TVA-BFN-TS-421

**BROWNS FERRY NUCLEAR PLANT (BFN) - UNITS 1, 2, AND 3 - TECHNICAL SPECIFICATIONS (TS) CHANGE 421 - FRAMATOME FUEL DESIGN AND STORAGE**

Proposed Technical Specifications Changes (mark-up)

#### 4.2.1 Fuel Assemblies

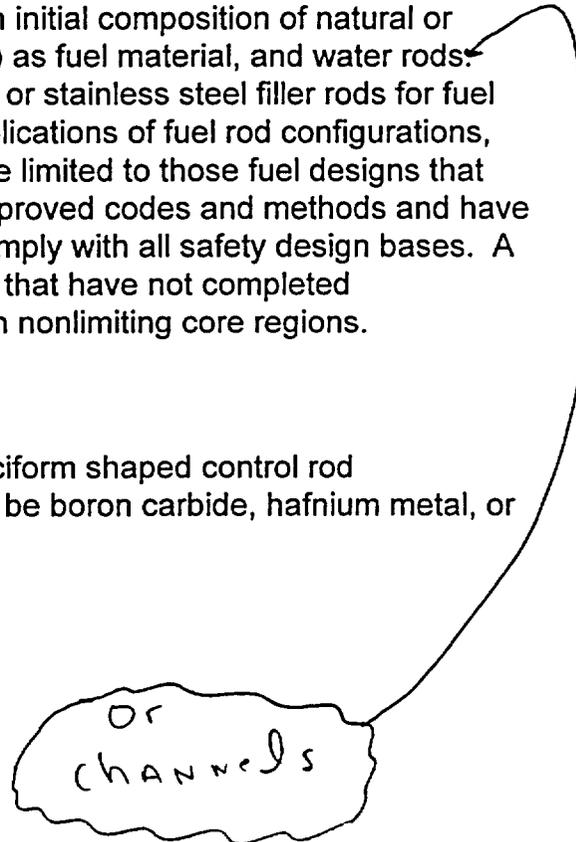
The reactor shall contain 764 fuel assemblies. Each assembly shall consist of a matrix of Zircalloy fuel rods with an initial composition of natural or slightly enriched uranium dioxide ( $UO_2$ ) as fuel material, and water rods. Limited substitutions of zirconium alloy or stainless steel filler rods for fuel rods, in accordance with approved applications of fuel rod configurations, may be used. Fuel assemblies shall be limited to those fuel designs that have been analyzed with NRC staff approved codes and methods and have been shown by tests or analyses to comply with all safety design bases. A limited number of lead test assemblies that have not completed representative testing may be placed in nonlimiting core regions.

OR  
channels
